PRODUCT/PROCESS CHANGE NOTICE (PCN)

PCN #: **TB1405-01** DATE: **July 7, 2014**
 Product Affected: **TQFP-44, TQFP-64**
 shipped in Tape & Reel
 (Refer to Attachment II for affected part#)
 Date Effective: **October 7, 2014**

ATTACHMENT I - PCN #: TB1405-01

From: Carrier Tape (P8-300-E64) - Pocket Dimensions

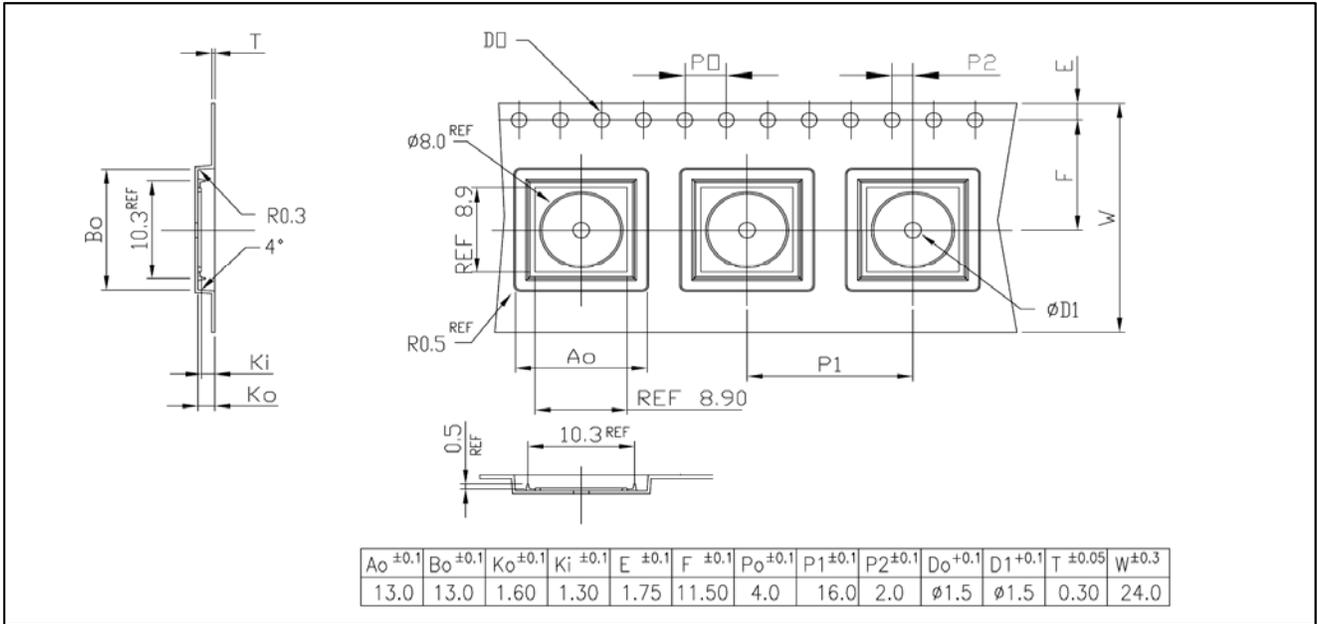
The new carrier tape has changes in pocket design and dimensions and complies with the requirements of EIA-481-D standard.

Refer to Table 2, Figure 1 and 2 for the comparison of the existing and new carrier tape in terms of carrier tape pocket dimensions and pocket designs as well as quantity per reel respectively.

Attachment III - Existing Carrier Tape Drawing

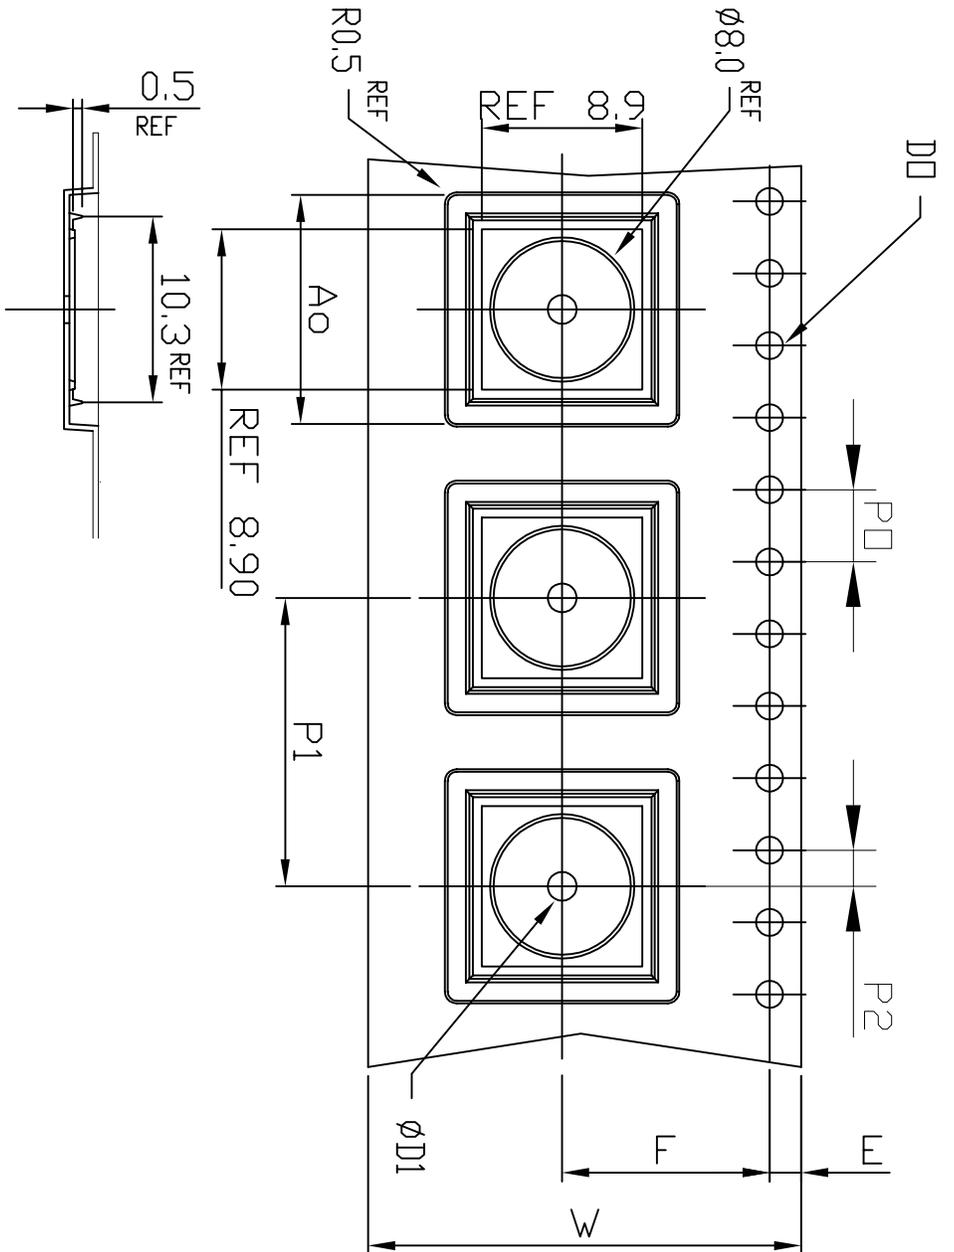
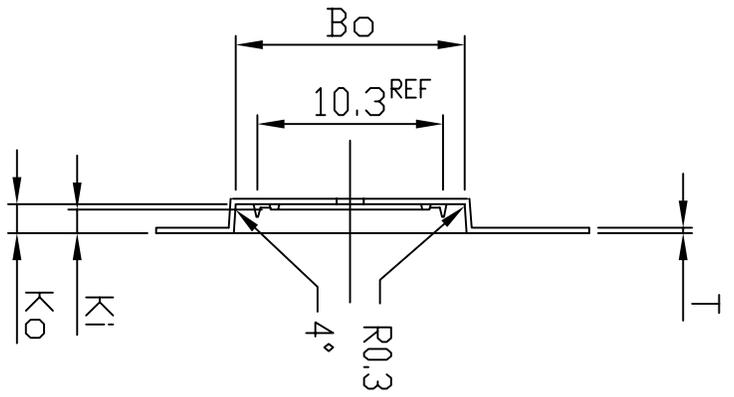
| <input type="checkbox"/> Equipment | The new carrier tape has changes in pocket design and dimensions. |
| <input type="checkbox"/> Data Sheet | Attachment III - Carrier Tape Drawings |
